Metropolitan Planning Commission

Staff Reports

January 10, 2008

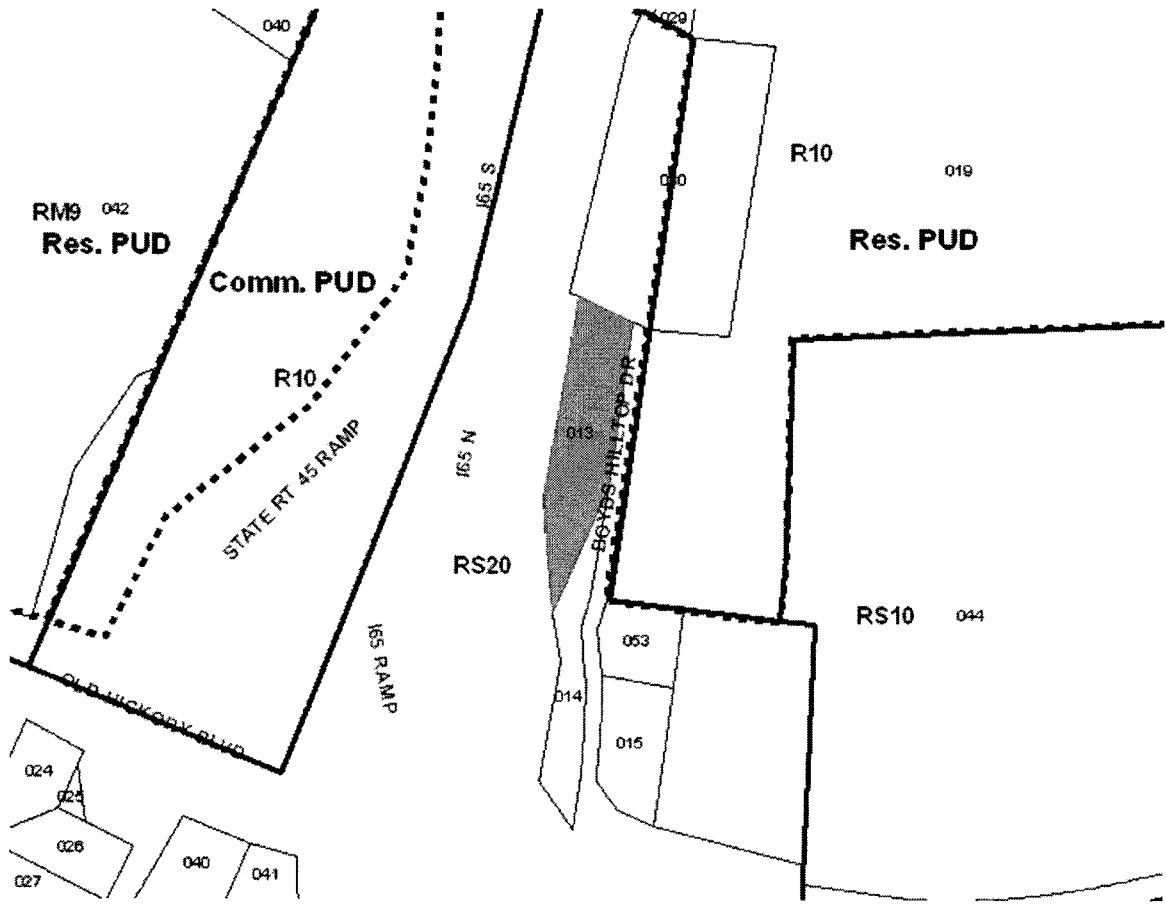
1. Add the, "Special Notes" reflected on sheet 1 of the previously approved preliminary plat. Specifically, the notes should reference the flood study submitted to Metro, cite the title and date of publication. Furthermore, the "Special Notes" should reference all Stormwater Variances and provide a cursory explanation of said variances. As such, cite the following Approved Stormwater Variances: 2006-005, 2006-127, 200700031.

2. Show and label the proposed and existing 100 Year Floodplain Lines in addition to the Proposed and Existing Floodway Lines.
3. With reference to comment number 2 above, reference the approved document(s) that allow for the relocation of the Floodway and 100 Year Floodplain Lines. Specifically, cite the CLOMR case number.

4. CLEARLY show and label all Water Quality Measures.
5. Add another note in the, 'Special Notes' section stating 15 acres of off-site is being treated for water quality to mitigate for the portion of the lots on the current concept plan that are not being treated for water quality.

6. With reference to comment number 5 above, cite the Maintenance Agreement Instrument Number for the Pond treating the off-site water: 200704230047709.

1. The gazebo shall be relocated out of the floodplain.
2. Identify required buffer yards as required by Zoning.
3. The total number of duplex lots along the extension of Woodymore Drive shall be limited to four, and shall be located near the front end of the extension. Four additional duplex lots may be provided on lots proposed on the west side of the stream. Duplex lots on the west side of the stream shall be located on corner lots within the R10 zoning district only. Final location of duplex lots shall be approved by planning staff with the final plat.

4. All Stormwater conditions listed above shall be addressed prior to final plat, and must be shown on the preliminary plat.
5. Pursuant to 2-3.4.e of the Metro Subdivision Regulations, because this application has received conditional approval from the Planning Commission, that approval shall expire unless revised plans showing the conditions on the face of the plans are submitted prior to any application for a final plat, and in no event more than 30 days after the date of conditional approval by the Planning Commission.

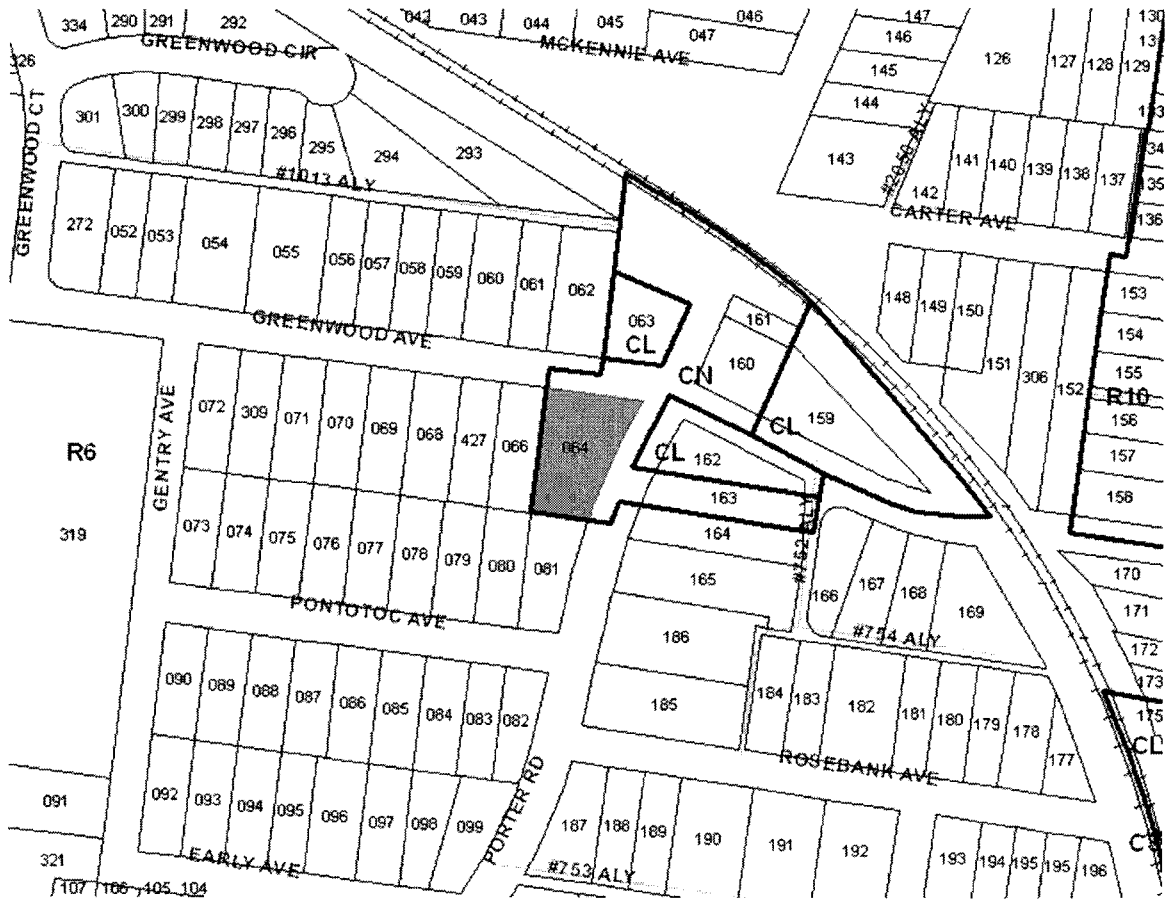
1. The PUD final site plan shall include a sidewalk along the property frontage on Music Valley Drive, and Music City Circle.
2. The PUD final site plan shall include walkway This approval does not include any signs. Signs in planned unit developments must be approved by the Metro Department of Codes Administration except in specific instances when the Metro Council directs the Metro Planning Commission to review such signs.
3. The requirements of the Metro Fire Marshal's Office for emergency vehicle access and adequate water supply for fire protection must be met prior to the issuance of any building permits.

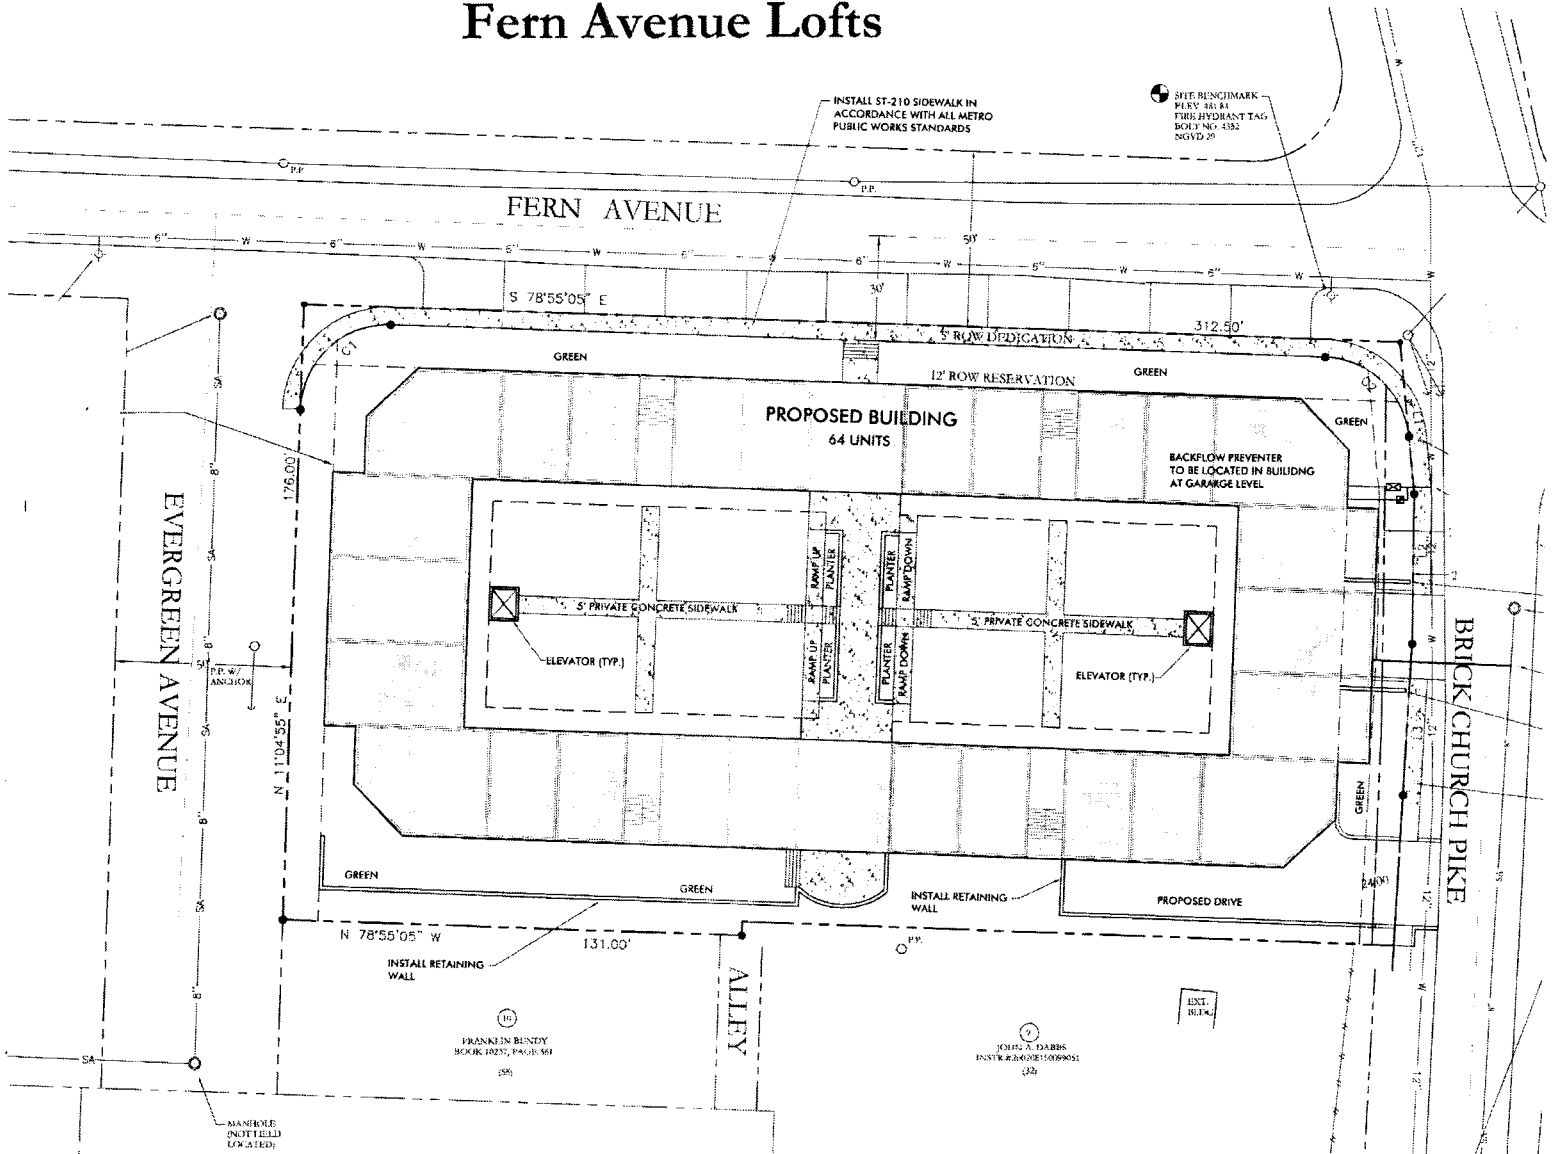
Identify plans for recycling collection. Coordinate solid waste collection and disposal plan with the Department of Public Works Solid Waste Division. Provide a twenty five (25') foot minimum overhead clearance.

Along Fern Avenue, construct a six (6') foot furnishing zone and eight (8') foot sidewalk, consistent with the Strategic Plan for Sidewalks & Bikeways.

Along Brick Church Pike, construct a five (5') foot furnishing zone and six (6') foot sidewalk, consistent with the Strategic Plan for Sidewalks & Bikeways.

Provide documentation of adequate sight distance at project access locations, and at the intersection of Brick Church Pike and Fern Avenue resulting from the proposed development.

1. The backflow preventer must be located within the building, as indicated on the plans.
2. Add a B-5 buffer along the southern property line. In areas where the retaining wall is approximately 5' from the property line, include landscaping similar to that currently shown on the plan.
3. Show correct density on cover sheet of plan.
4. Show access to the stair towers on the plan.
5. A final consolidation plat must be recorded prior to the issuance of any building permit.

6. All elevations must be submitted for review with the SP final site plan.
7. The Fern Avenue elevation must be revised with the SP final site plan submittal to depict a flat parapet, smaller pedestrian entrance, and enclosed stairwells between the blocks of units.

8. The final SP site plan shall include a site utility electrical plan that satisfies NES and Planning Department requirements.
9. This SP is limited to multi-family residential use.

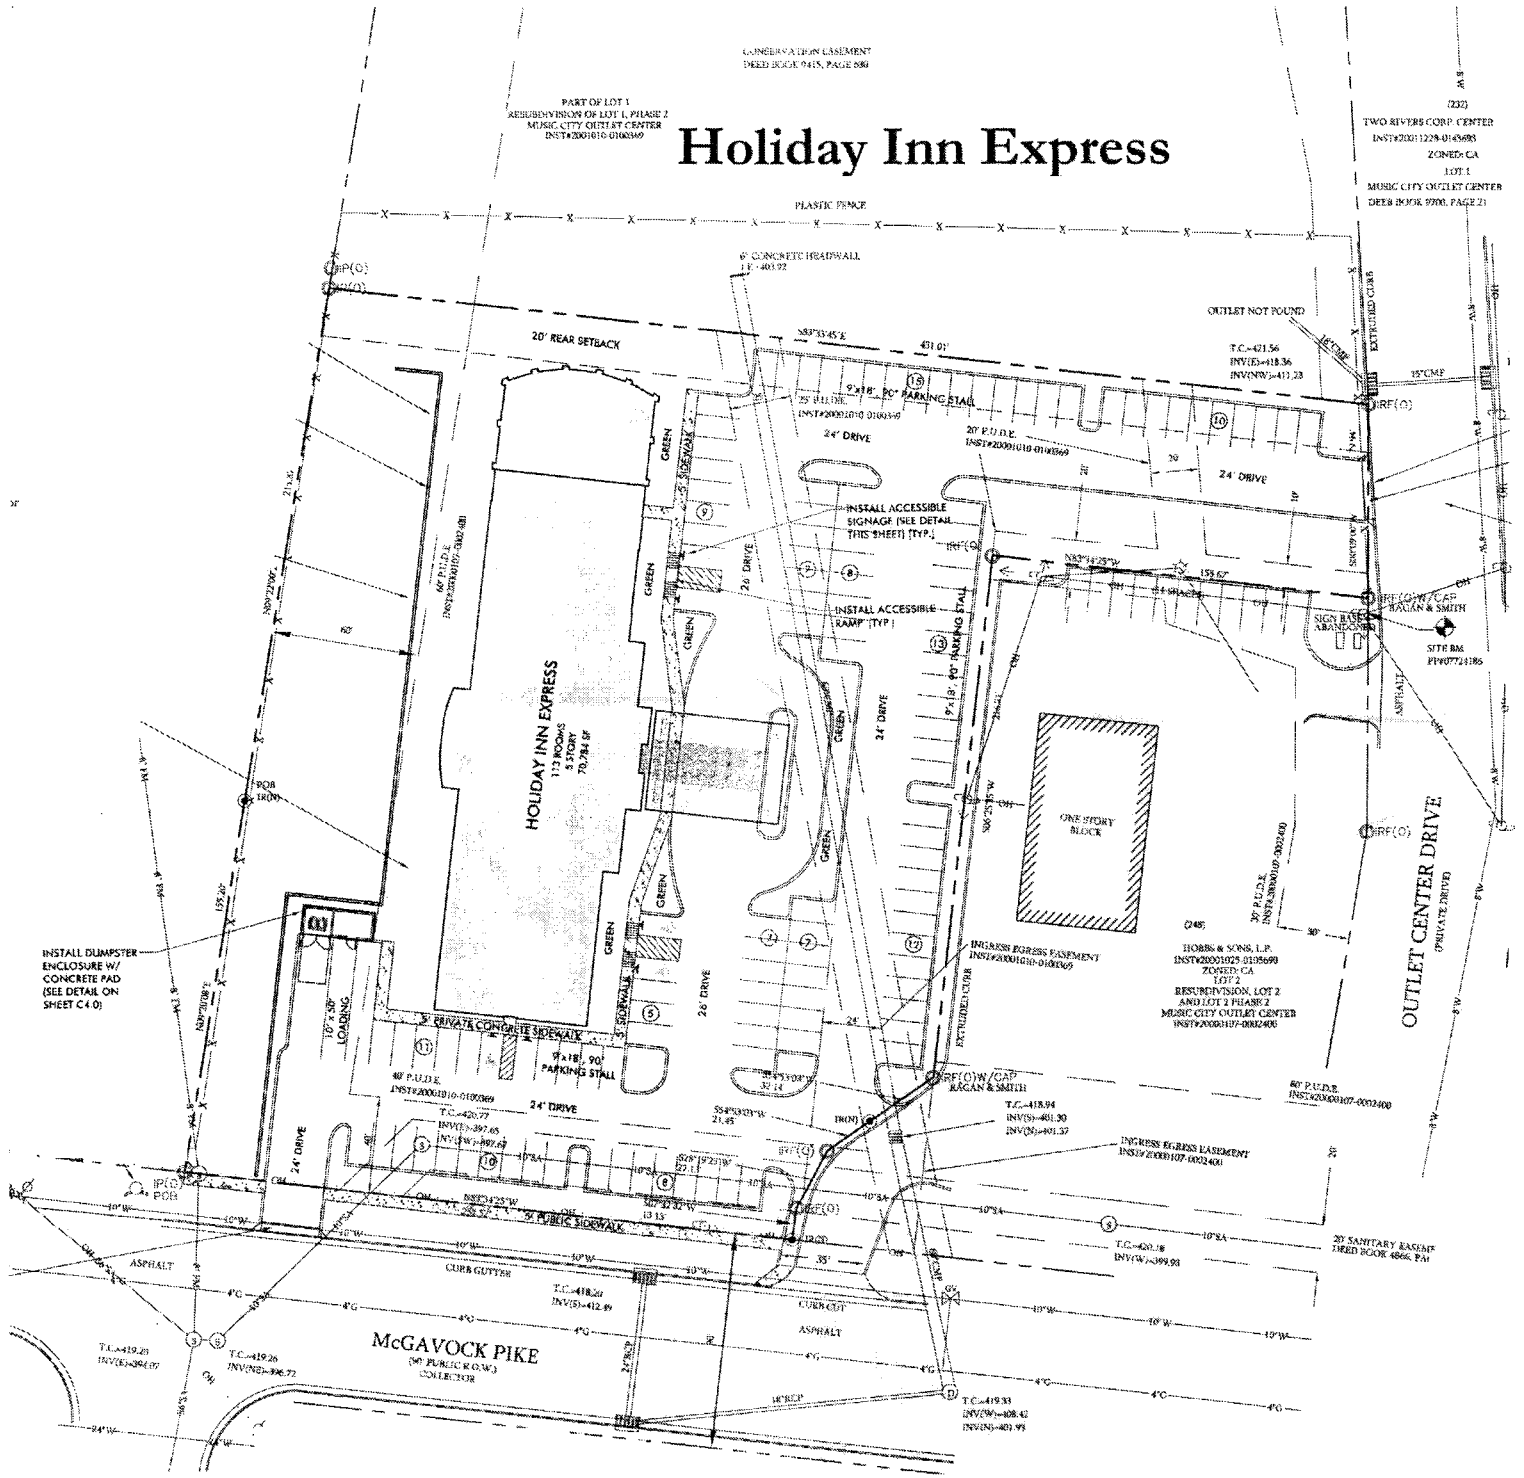
A sidewalk is proposed along McGavock Pike for pedestrian access. An additional sidewalk pedestrian connection is needed along Outlet Center Drive. The recent expansion of Two Rivers Corporate Center, as well as the commercial retail growth within the adjacent Music Valley PUD have increased pedestrian activity in the area as employees, tourists and patrons of nearby establishments travel along Outlet Center Drive and McGavock Pike. The increase in pedestrian activity has
